# Access Compliance Report

## Public Rights-of-Way

### (Curb Ramps)

Intersection ID: 13985	Main Street: CAMDEN_RD	Cross Street: EAST_BV	Location: NE
ADA ID: F02D38210A58	Ramp Type: Perp	Initial Pass/Fail: Fail	Overall Compliance: No
		Severity Score: 37.5

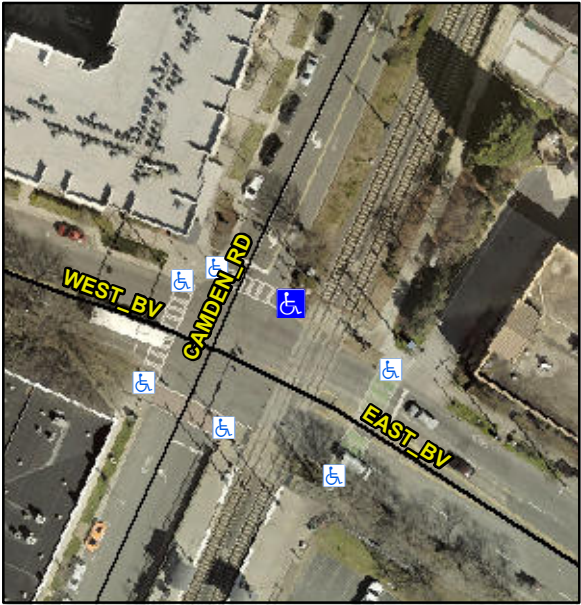
Codes/Mitigation Info/Possible Solution			Field Measurements/Component Compliance		
	Possible Solutions:		<b>Compliance</b>	<b>Description</b>	<b>Data</b>
	<b>Remove &amp; Replace Entire Ramp.</b>		<b>No</b>	Ramp Length (in)	50.0
			<b>Yes</b>	Ramp Width (in)	48.0
			<b>N/A</b>	Flare Type LT	N/A
			<b>N/A</b>	Flare Slope LT (%)	N/A
			<b>N/A</b>	Flare Traversable LT?	N/A
			<b>N/A</b>	Landing Length (in)	N/A
			<b>N/A</b>	Landing Width (in)	N/A
			<b>N/A</b>	Landing Slope (%)	N/A
			<b>N/A</b>	Landing X Slope (%)	N/A
<p>Surveyor Notes:</p> <p><b>N/A</b></p> <p>PROW/ADA:</p> <p><b>R304.2.2, R304.5.3</b></p>			<b>N/A</b>	Flare Type RT	N/A
			<b>N/A</b>	Flare Slope RT (%)	N/A
			<b>N/A</b>	Flare Traversable RT?	N/A
			<b>N/A</b>	DWS Provided?	N/A
			<b>N/A</b>	DWS Contrast?	N/A
			<b>N/A</b>	DWS Length (in)	N/A
			<b>N/A</b>	DWS Full Width?	N/A
			<b>N/A</b>	DWS Offset (in)	N/A
			<b>N/A</b>	Shared Landing?	N/A

<b>N/A</b>	Gutter Ponding?	N/A
			<b>N/A</b>	Gutter Lip Ht (in)	N/A
			<b>N/A</b>	Painted X Walk1?	Yes
				X Walk 1 Direction	To NW
			<b>N/A</b>	X Walk 1 Width (in)	99.0
				X Walk 1 Slope (%)	1.6
				X Walk 1 X Slope (%)	10.0
			<b>N/A</b>	Ramp inside XWalk1?	Yes
			<b>N/A</b>	Road Slope (%)	N/A
			<b>N/A</b>	Road X Slope (%)	N/A
			<b>N/A</b>	Any Obstructions?	N/A
				Obstruction Type	
			<b>N/A</b>		
			<b>N/A</b>		
			<b>N/A</b>		
			<b>N/A</b>		
			<b>N/A</b>		
			<b>N/A</b>		
			<b>N/A</b>		
			<b>N/A</b>		
			<b>N/A</b>		
Total Cost:		\$ 1850.00			
			<b>N/A</b>		
			<b>Yes</b>	Surface Condition? (G/P)	Good
